RESPONSE TO REQUEST FOR ADDITIONAL INFORMATION

US-APWR Design Certification

Docket No. 52-021

RAI NO.: NO. 490-3732 REVISION 0
SRP SECTION: 03.08.01 – Concrete Containment
APPLICATION SECTION: 3.8.1
DATE OF RAI ISSUE: 11/23/2009

Figure 1 Section View and Stresses

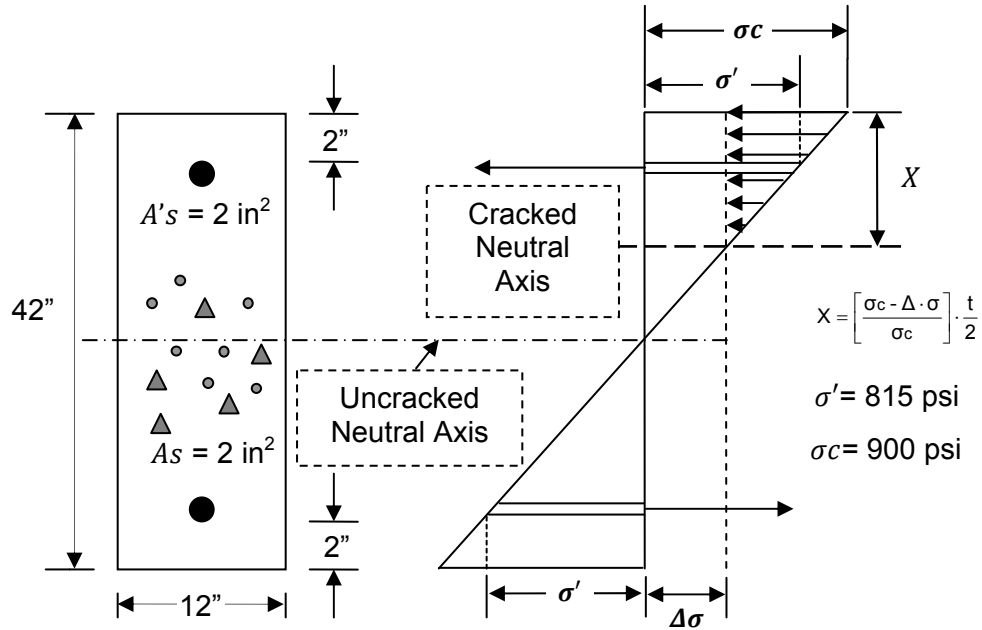
The staff finds that MHI's response does not clearly indicate how thermal forces and moments are reduced according to the concrete cracking depth. In MHI's response, a notation, σ_c1 , is used to denote the extreme fiber stress of the concrete; however, in the example given at the end, an additional notation, σ_c2 , is introduced without any explanation. MHI is requested to clarify this confusion. Also, MHI is requested to provide a calculation example that is taken from the US-APWR design, and that will have numerical results clearly showing the amount of reduction in forces and moments and the concrete cracking depth.

Due to changes in the US-APWR prestressed concrete containment vessel (PCCV) analysis and design approach, the variable, σ_c2 , is no longer applicable. As before, the reduction is based on redistribution of section forces and moments that occurs from the concrete cracking. Concrete is considered to crack when the section is subject to tension and the neutral axis is shifted.

The following example is provided to show how concrete cracking in the PCCV cylindrical section is considered. The stress across a concrete section is calculated as an un-cracked

section initially and then the stress due to concrete cracking is calculated to adjust the concrete section given the effects of the cracked concrete behavior.

The example presented herein is an example of a PCCV concrete section when subjected to a thermal gradient with reinforcement provided on both faces and concrete cracking is considered.

Uncracked concrete stress, σ_c :

$$\sigma_c = \frac{1}{2} \alpha E_c \Delta T = 900 \text{ psi}$$

The tension and compression reinforcement along with the concrete compression stress are adjusted with the $\Delta\sigma$ value calculated previously to account for concrete cracking condition. The tension and compression reinforcement and concrete compression stress are adjusted as follows:

Due to the effects of concrete cracking have on the cross section, the neutral axis is shifted to reflect such conditions. The cracked neutral axis is therefore calculated as follows.

$$X = \left(\frac{\sigma_c - \Delta\sigma}{\sigma_c}\right) \frac{t}{2} = \left(\frac{388}{900}\right) 21 = 9.05 \text{ in.}$$
